16197A-01

<u>SERVICE NOTE</u>

Agilent 16197A Bottom Electrode SMD Test Fixture

Dimensional distortion of the contact assembly interferes with operations

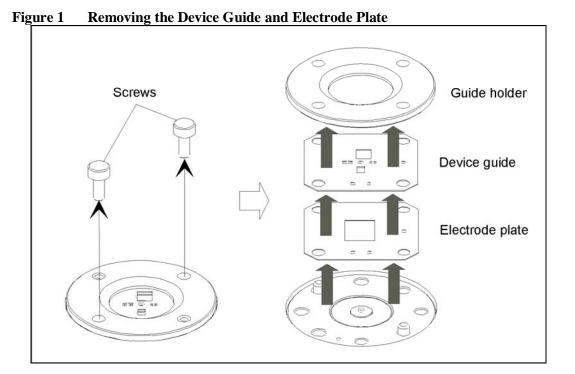
In some 16197A's that have the above serial numbers, there is the possibility that the contact assembly (P/N 16197-60001) is out of dimensional tolerance. In this case, it interferes with the operation to change the orientation of the contact assembly for using unused clean area of the center electrode.

Check if you can change the orientation of the contact assembly with no friction in accordance with the following procedure. If there is a problem, replace the contact assembly with a new one.

- **Step 1.** Take off the guide holder, and remove the device guide and electrode plate as shown in Figure 1.
- **Step 2.** Remove the four screws from the upper side of the fixture, and then remove the contact assembly and flange as shown in Figure 2.
- **Step 3.** Rotate the contact assembly and set it in place in increments of 45 degrees. Confirm that you can set it with no friction.
